# UNITED STATES PATENT AND TRADEMARK OFFICE

APPLICATION NO.	FILING DATE	FIRST NAMED INVENTOR	ATTORNEY DOCKET NO.	CONFIRMATION NO.
10/790,691	03/03/2004	David Grant Middleton	07045.0002.00US00	2309
32894	7590	07/06/2006	EXAMINER	
HOWREY LLP C/O IP DOCKETING DEPARTMENT 2941 FAIRVIEW PARK DR., SUITE 200 FALLS CHURCH, VA 22042			POPOVICS, ROBERT J	
			ART UNIT	PAPER NUMBER
			1724

<b>Office Action Summary</b>	<b>Application No.</b> 10/790,691	<b>Applicant(s)</b> MIDDLETON, DAVID GRANT	
	<b>Examiner</b> Robert J. Popovics	<b>Art Unit</b> 1724

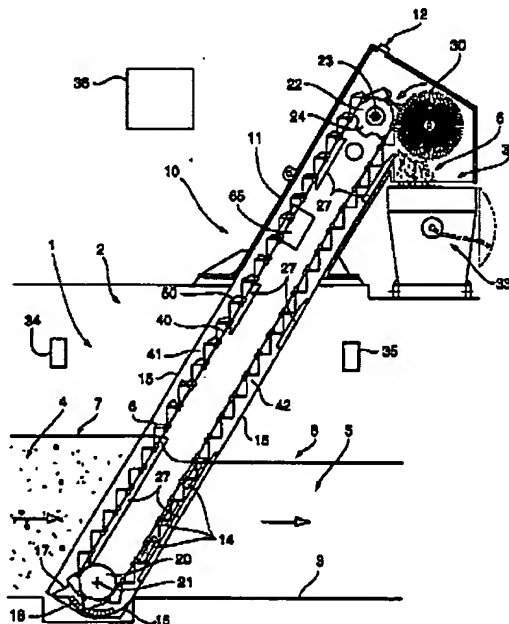
Claims 3-5 and 13-15 are rejected under 35 U.S.C. 103(a) as being unpatentable over **Larsen (US 5,800,701)**. Claims 3-5 and 13-15 essentially differ from **AAPA** by specifying a rotary brush or cleaning device. Larsen discloses the use of a rotary brush to clean an endless screen:

In view of this disclosure, it would have been obvious to one of ordinary art to employ a rotary brush in the system described by **AAPA**, in order to aid in the cleaning of the screen.
